From: [Lisa Baker](#)
To: [John Locklear](#); [Morgan, Steve](#)
Cc: [Black, Alexis](#); [Madden, Melissa](#)
Subject: RE: Enterprise follow up
Date: Wednesday, May 22, 2019 1:31:26 PM
Attachments: [image004.png](#)
[image001.png](#)
[2019.05.22.Enterprise WorkPlan - SIDESLOPE CUT FILL EVALUATION PLAN.pdf](#)

PROJECT TITLE:
SIDESLOPE CUT/FILL CALCULATION
ENTERPRISE ROAD CLASS III
RECYCLING & DISPOSAL FACILITY
CELL 17 AND VERTICAL EXPANSION CONSTRUCTION PERMIT
DADE CITY, PASCO COUNTY, FLORIDA

SIDESLOPE CUT/FILL CALCULATION PLAN

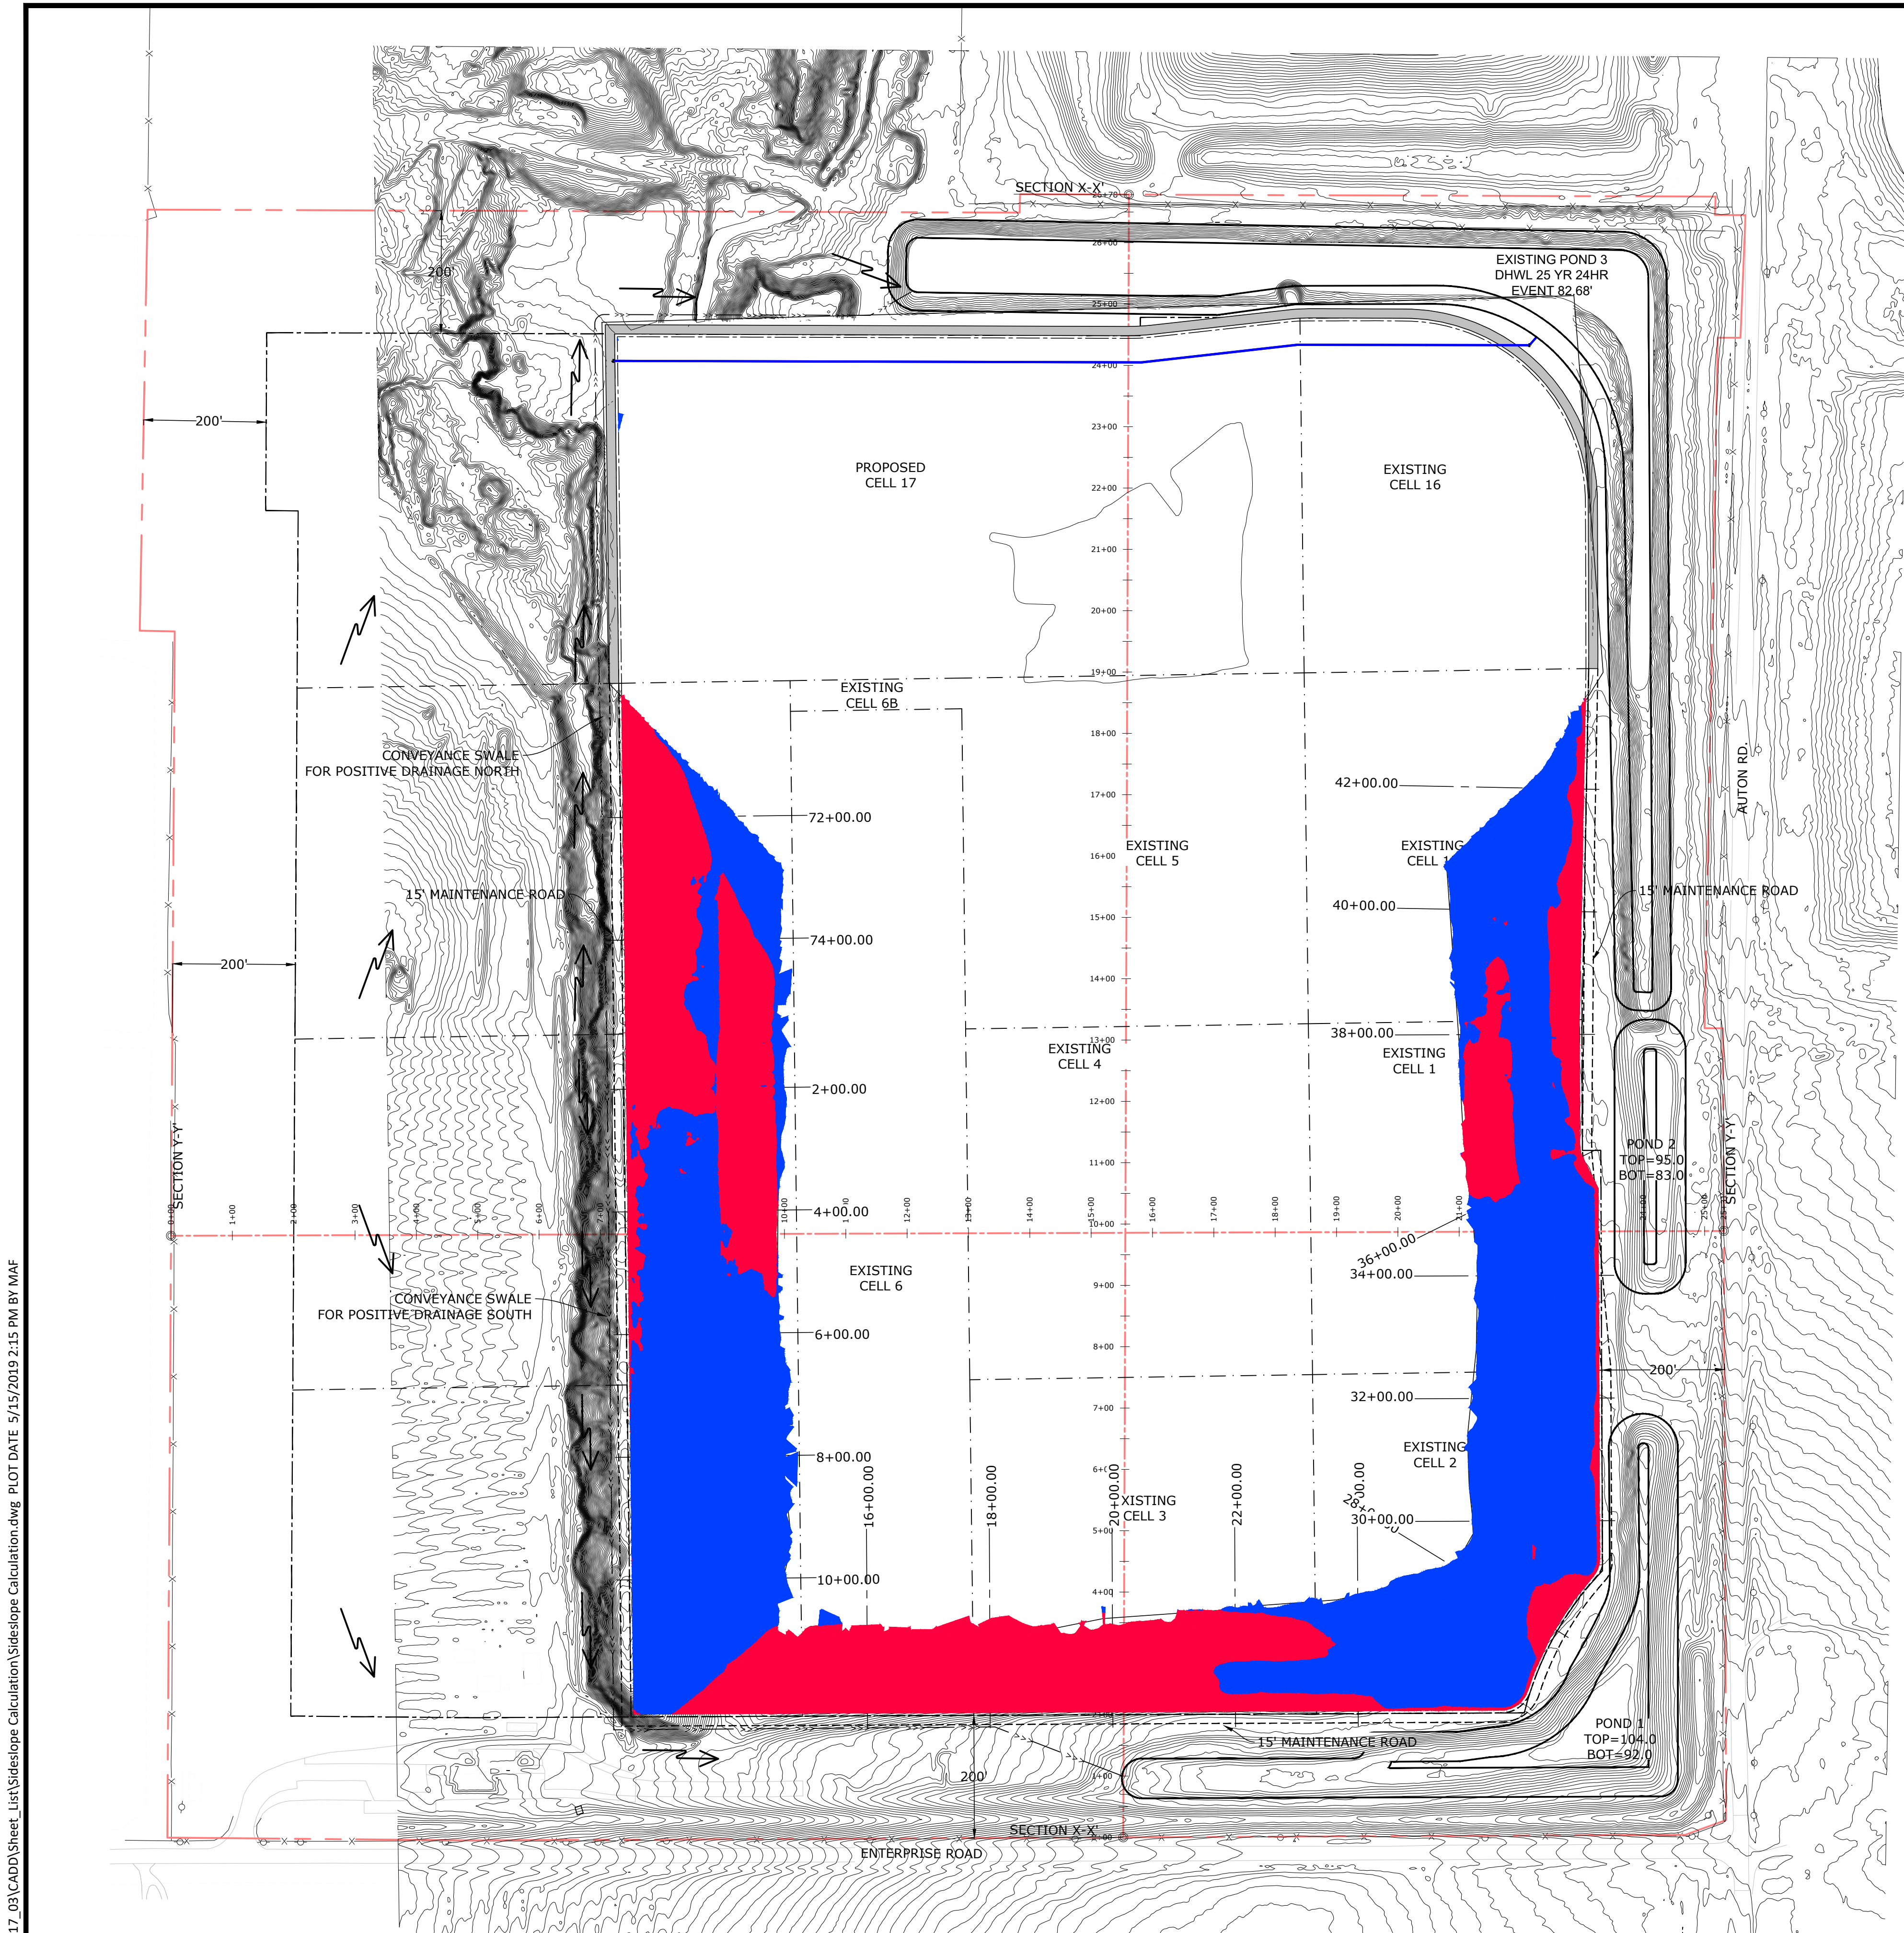
If you look at your closure design, the side slope cut-in becomes the bottom of your side slope conveyance ditch with the addition of the tack-on berms at closure. If the work plan proposes elimination of cut-in, that results in design change that is going to delay the permit because you are going to need to provide supporting information for the change in design of your closure side slope and stormwater conveyance ditches/system.

We do not currently intend to change the design. However, if our evaluation results indicate that a design change is necessary and prudent we would consider modifying the permit in the future. Based on my conversation with Alexis yesterday, the compliance group is okay with a 30-day evaluation period for us to submit the work plan. Basically, we need this time to evaluate construction options/approach, estimate costs/effort, and get the owner's approval of the resulting work plan. Please let me know if this approach is acceptable to the permitting group.

1. In our preliminary review of the issues raised by the Department, we have concluded that several key points need further evaluation related primarily to constructability and efficacy (e.g., the use of cut-in versus tack on berms) before we can submit a detailed work plan. Therefore, we would like to offer the following language for your consideration regarding the specific permit condition related to this issue:

“The owner shall expend all effort necessary to ensure that all external side slopes are in compliance with the facility’s operations permit within nine (9) months of issuance of the Cell 17 and Vertical Expansion Construction permit. The owner shall provide all documentation necessary to demonstrate permit compliance (e.g., as-built survey) prior to the nine-month deadline.”
